**DOCUMENT 00 90 00**  
**ADDENDUM**

**ADDENDUM No.:** 2

**RE:** HOUSING AUTHORITY OF THE CITY OF LA CROSSE  
2024 SMOKE ALARMS  
LA CROSSE, WISCONSIN 54601  
PROJECT NO. 24034

**SMOKE ALARMS MAY BE CEILING OR WALL MOUNTED IN APARTMENTS.**

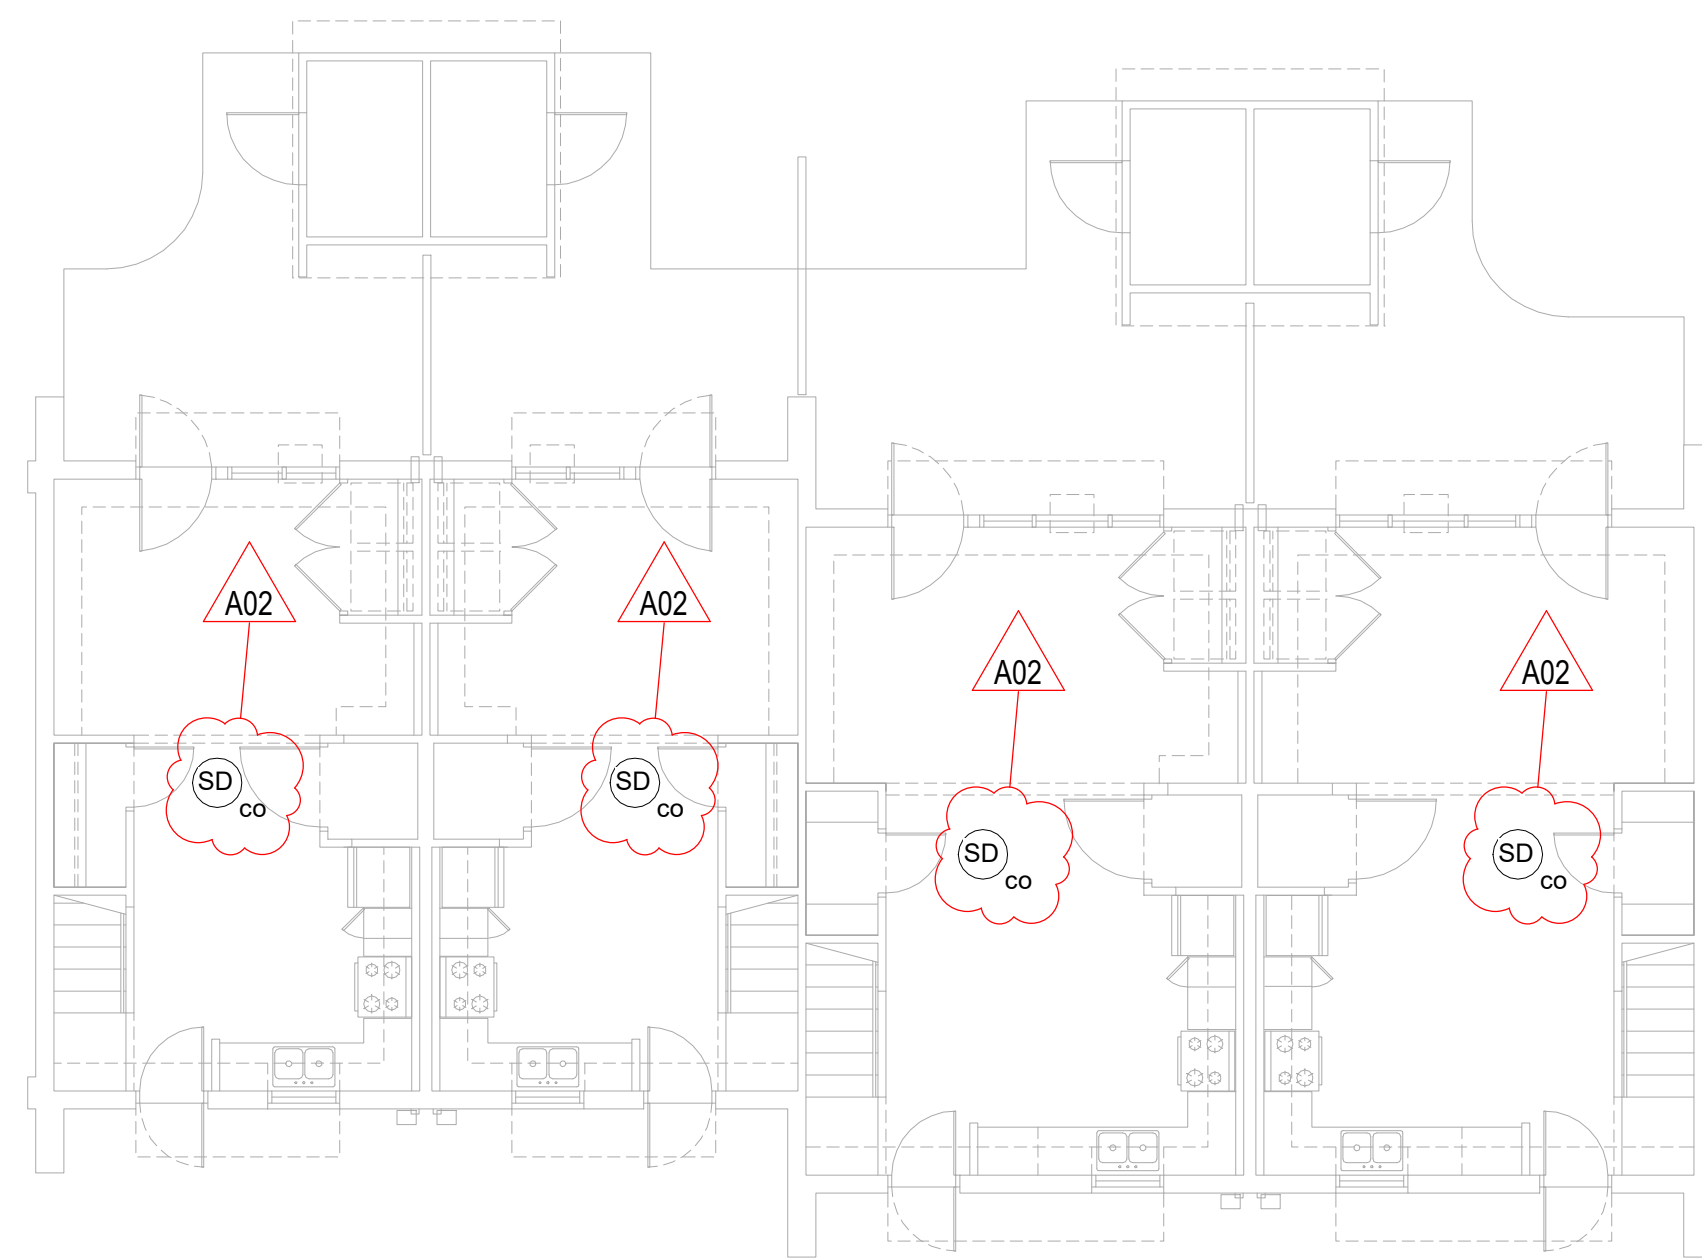
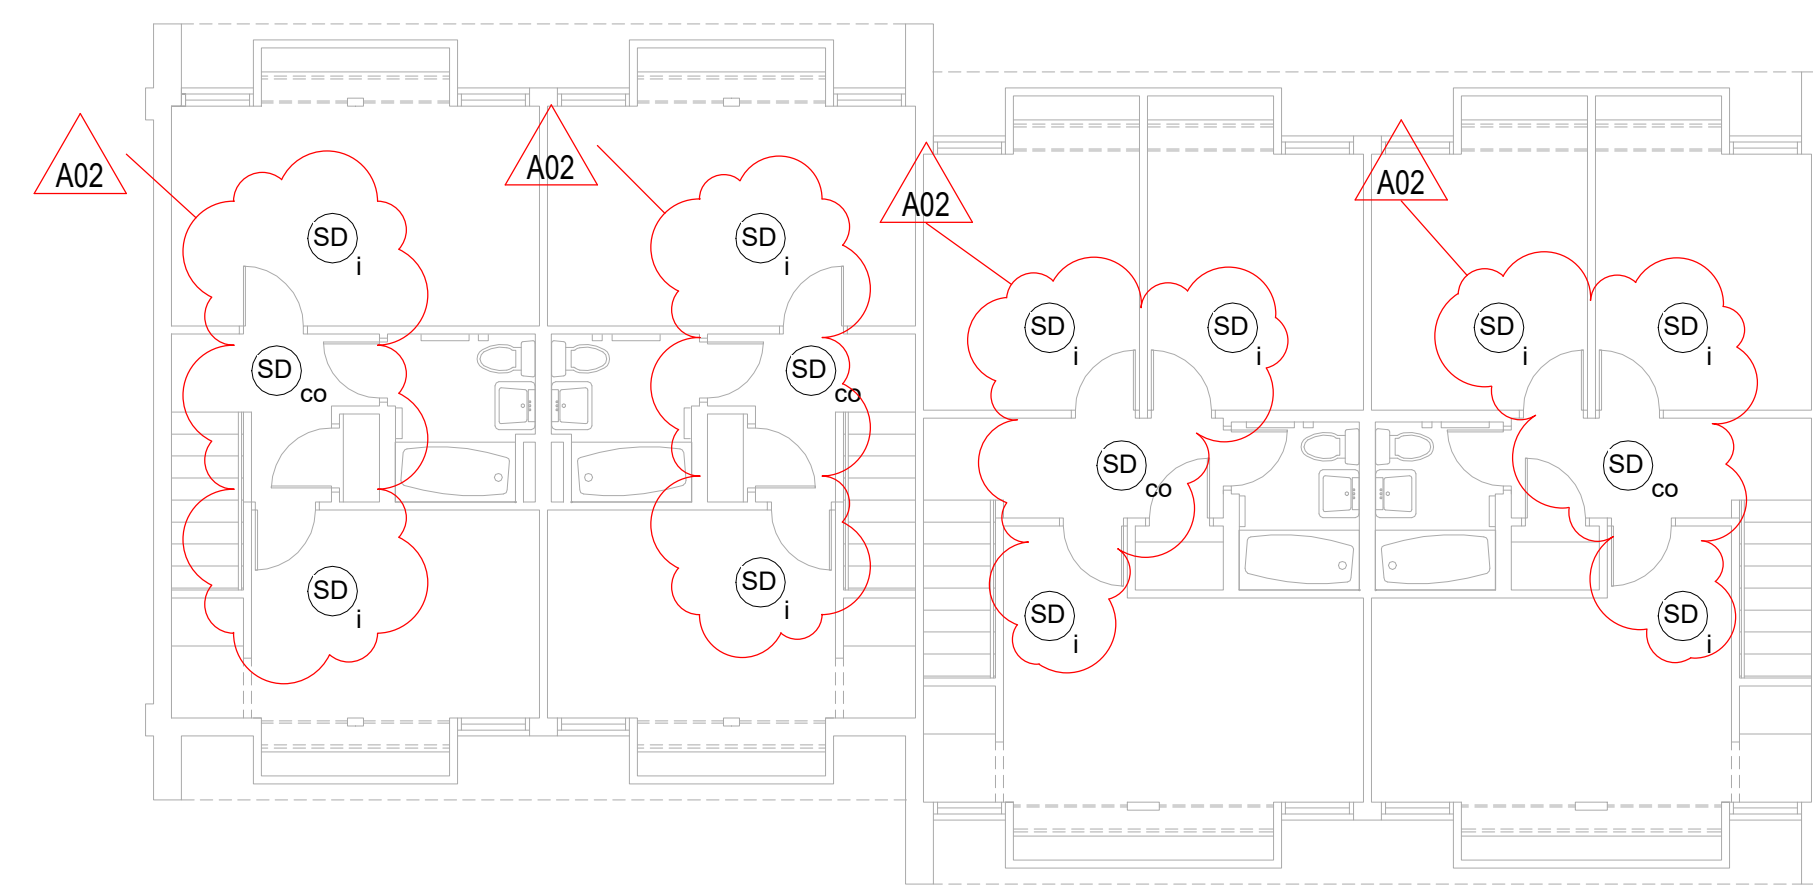
15. Sheet E801 SMOKE ALARM UNIT PLANS 30"x42"

- a. See the revised sheet included in this addendum. Disregard the previous version.
- b. Revised sheet to reflect a changed approach from wired smoke alarms to wireless. See clouded changes for requirements.
- c. Added notes regarding removal of existing equipment.
- d. Revised clouded plan views to remove wiring and conduit.

E901

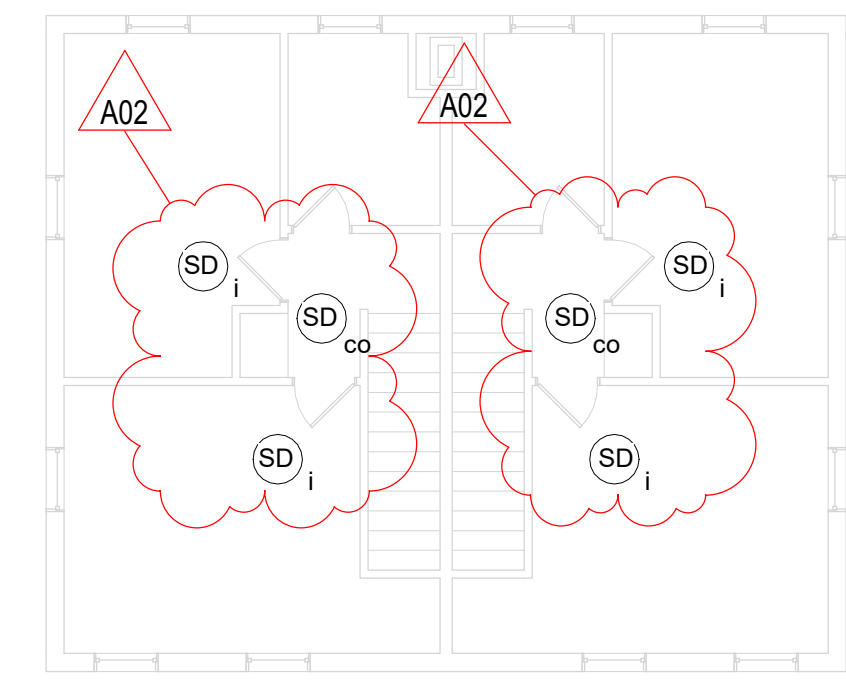
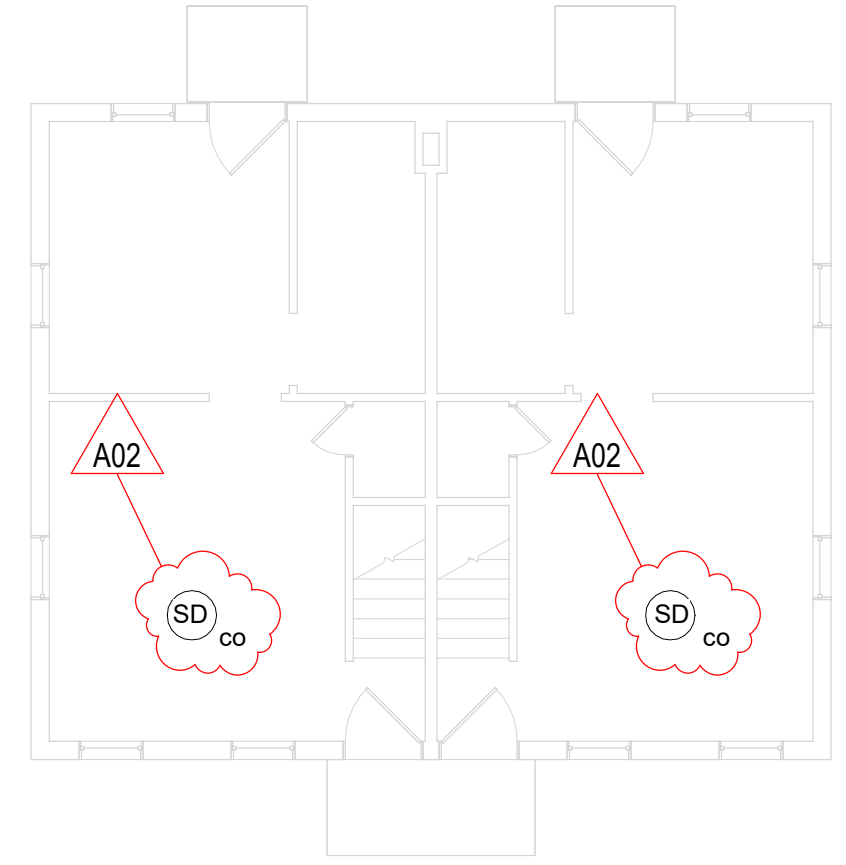
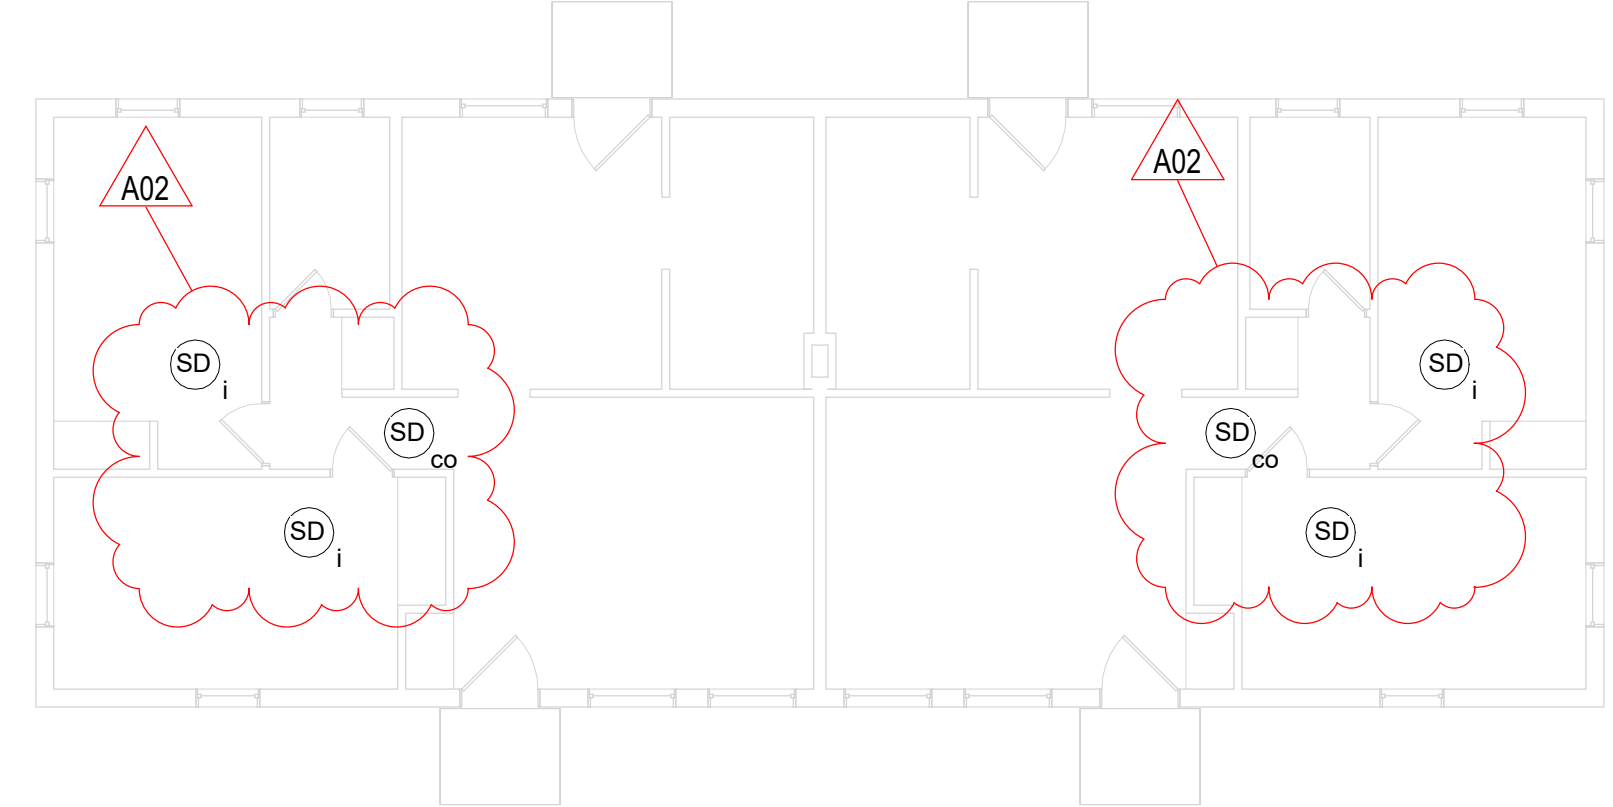
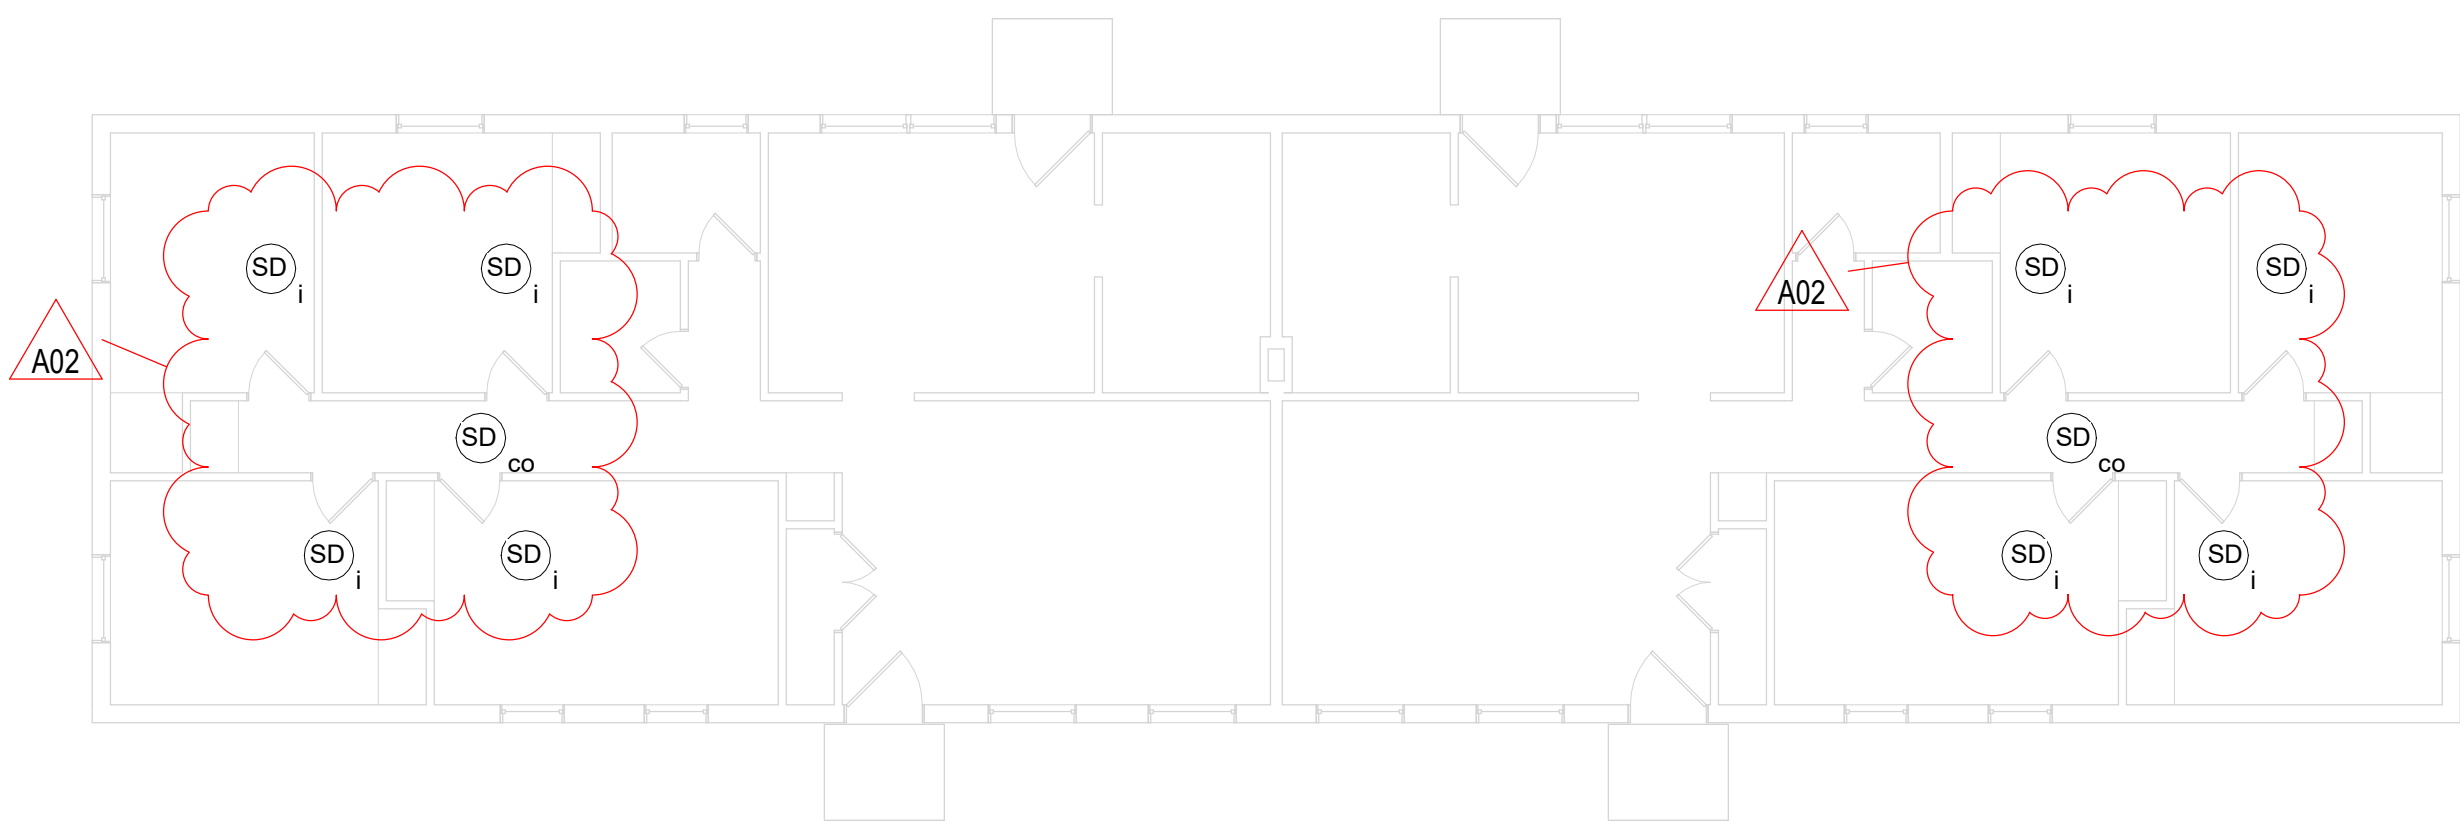
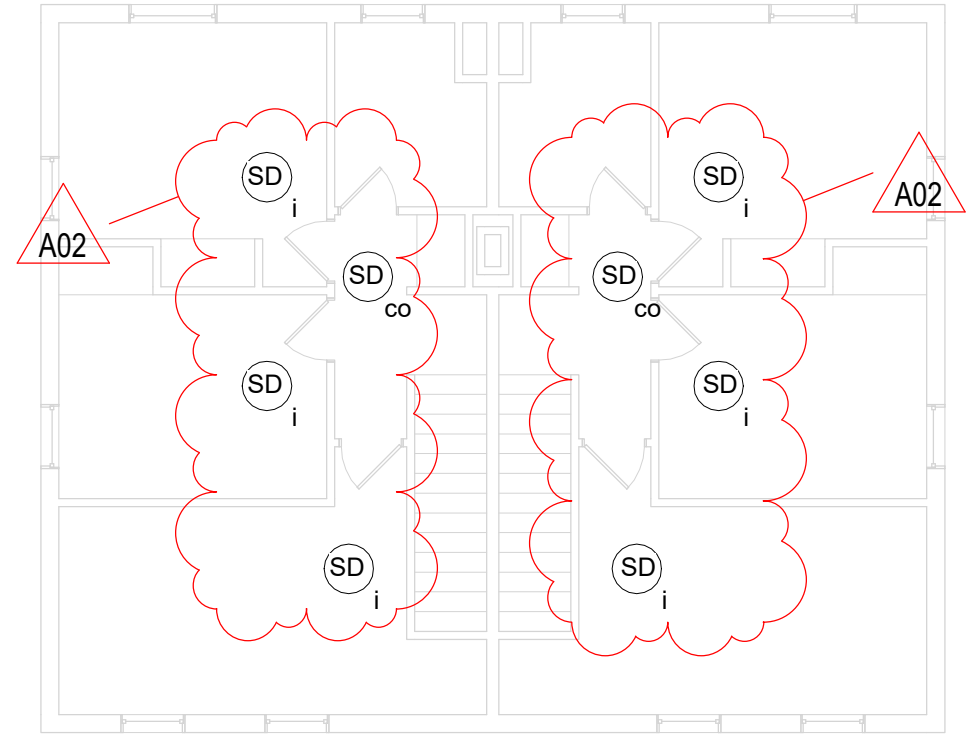
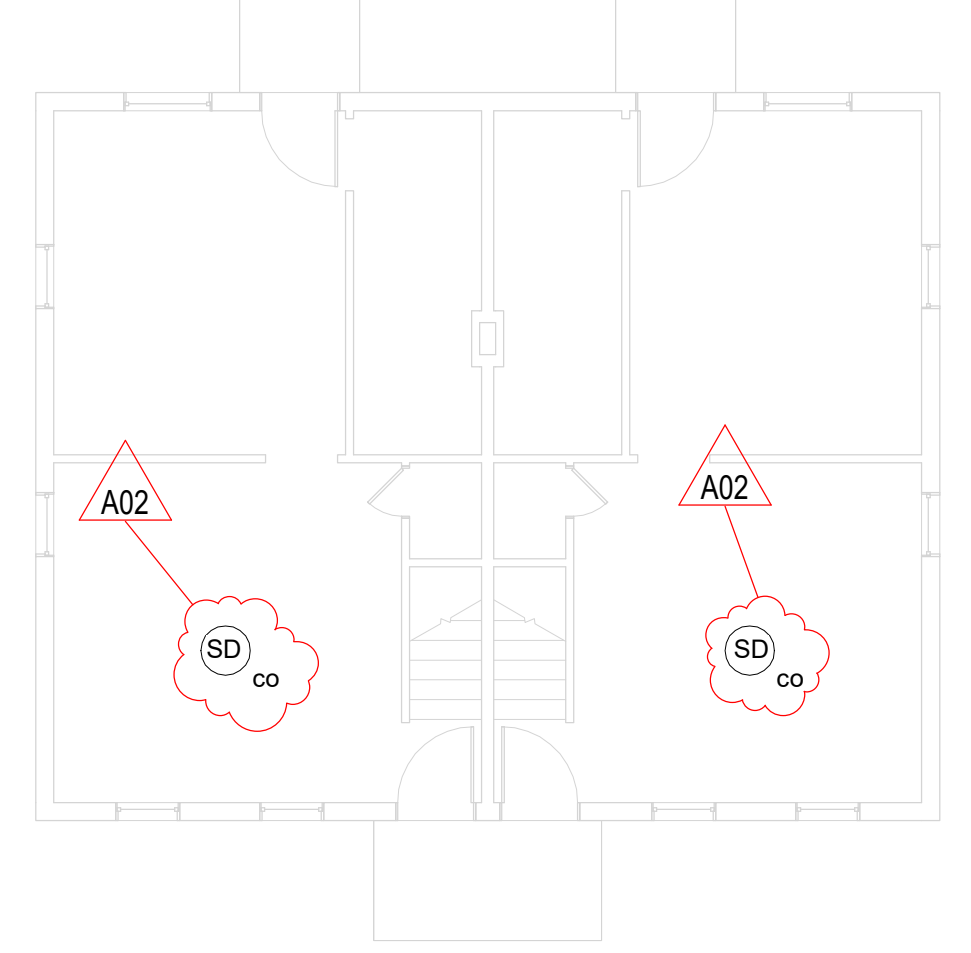
17. Sheet E901 SMOKE ALARM UNIT PLANS 30"x42"

- a. See the revised sheet included in this addendum. Disregard the previous version.
- b. Revised sheet to reflect a changed approach from wired smoke alarms to wireless. See clouded changes for requirements.
- c. Added notes regarding removal of existing.
- d. Revised clouded plan views to remove wiring and conduit.
- e. Added a photo to show an example unit interior.

**IF REMOVING ANY HARDWIRED DEVICE WITHOUT INSTALLING NEW DEVICE ON JUNCTION BOX, CAP ALL WIRES AND ADD DECORATIVE BLANK COVER TO JUNCTION BOX TO COVER OPENING TO FINISHED SURFACE. BASIS OF DESIGN IS: ARLINGTON #CP3540, OR EQUAL.**
